Subject GW topics for discussion at 2:00

I am going to include a brief summary of the concerns and recommendations which EPA has with the shallow groundwater monitoring well installation proposal by SWC (i.e., May 23, 2005).

ROUTE 561 DUMP SITE STRATEGIC SAMPLING LOCATIONS

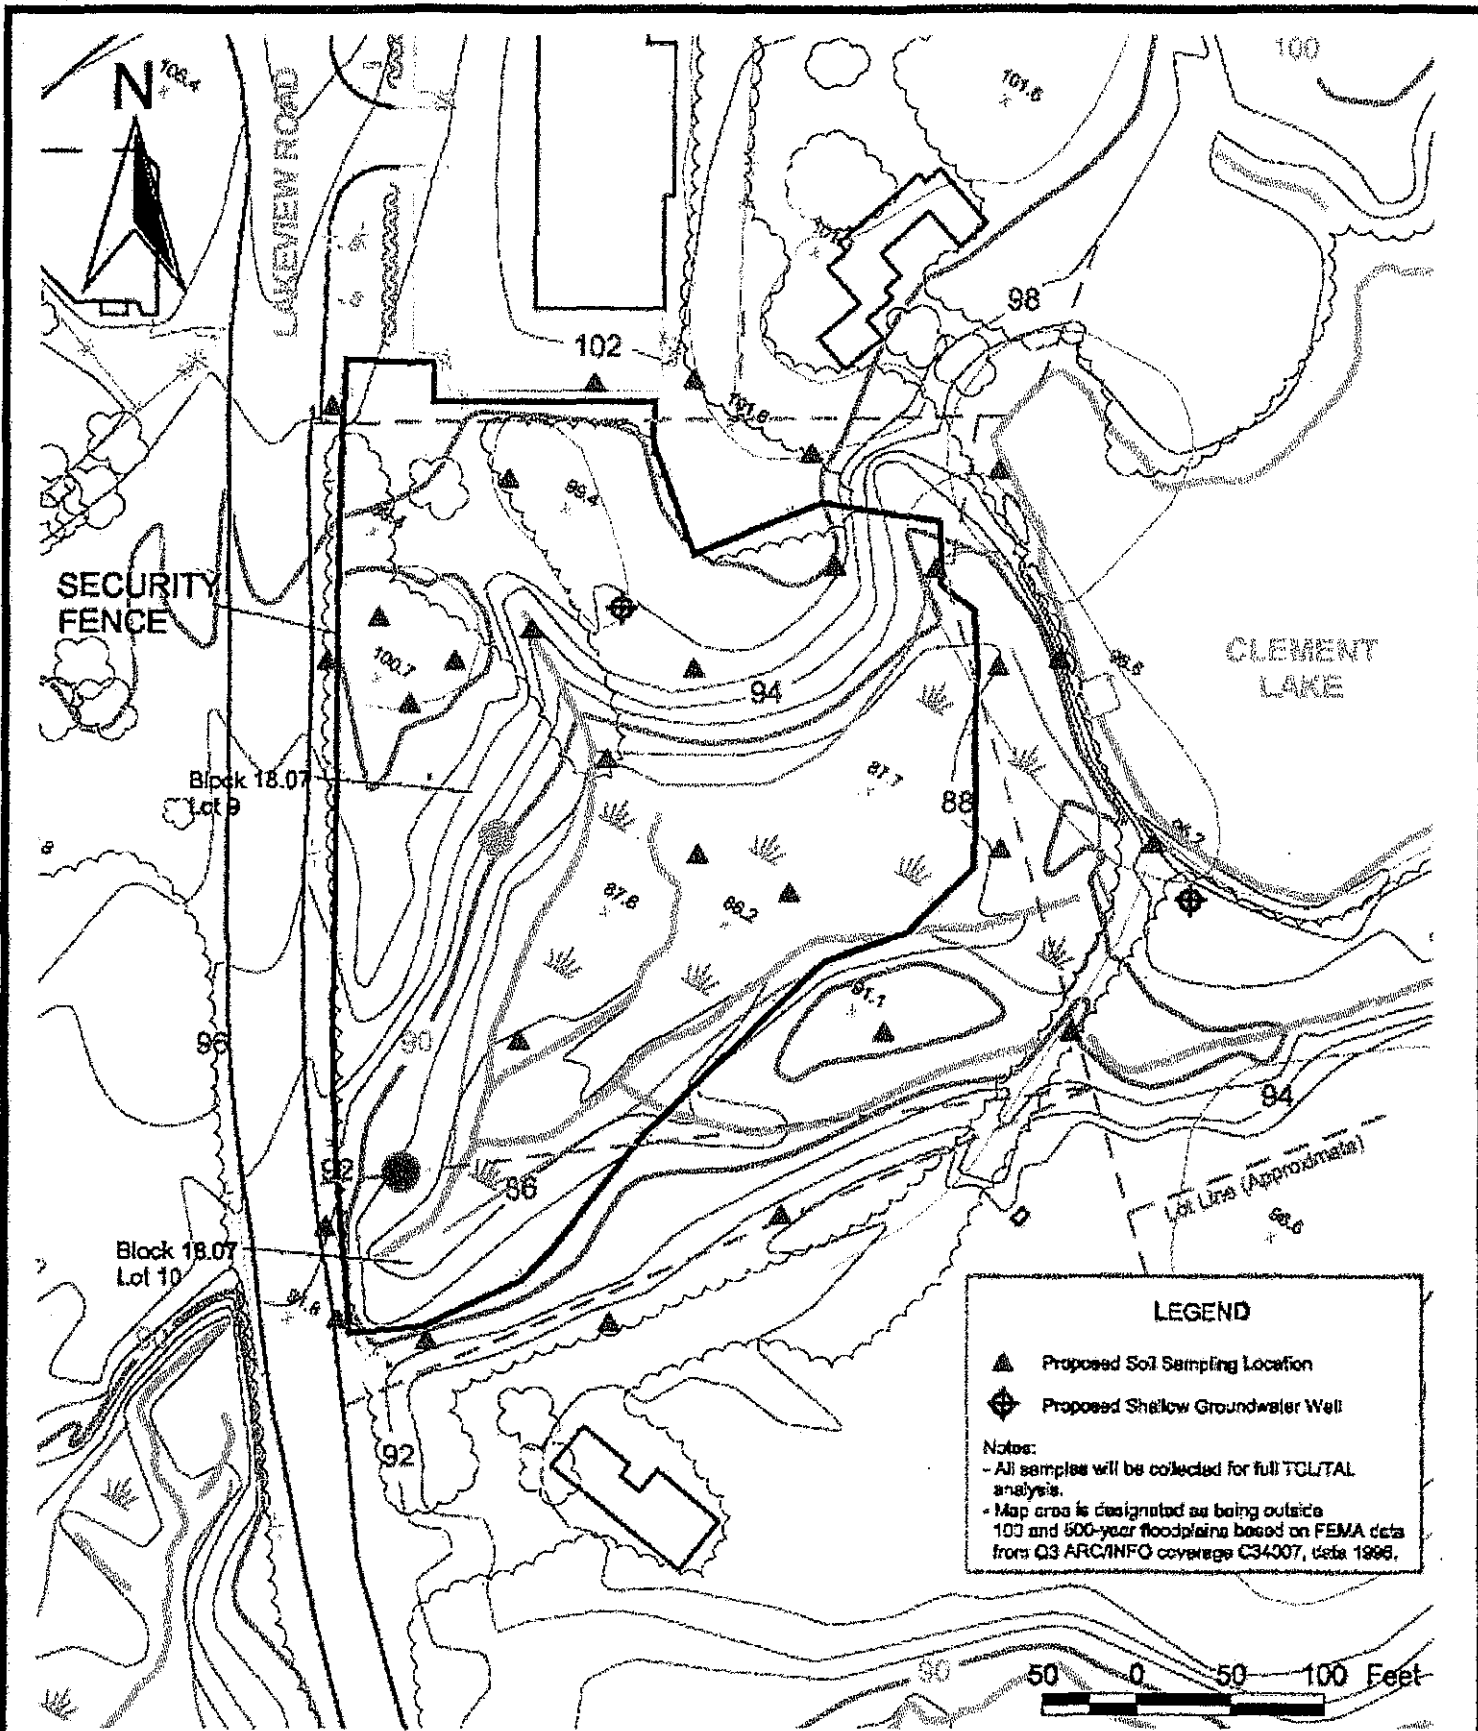
Rt. 561 Dump Site: EPA has concerns with the fact that only 1 of the previously 8 identified locations for gw screening locations, have been kept and is now proposed for a new shallow mw location. EPA admits that the Work Plan states that 3 wells were to be placed on the Dump site: in the source area, upgradient, and downgradient - however, these locations were to be selected based upon the data from the 8 screening points. Without reverting back to the screening program, EPA is therefore proposing the following locations be used for shallow gw monitoring locations, with the inclusion of one additional well. Bringing the total number of wells at the Dump site to 4. Figure attached. Note, two of the previously identified locations proposed by SW in their May 23, 2005 Tech Memo have been kept.
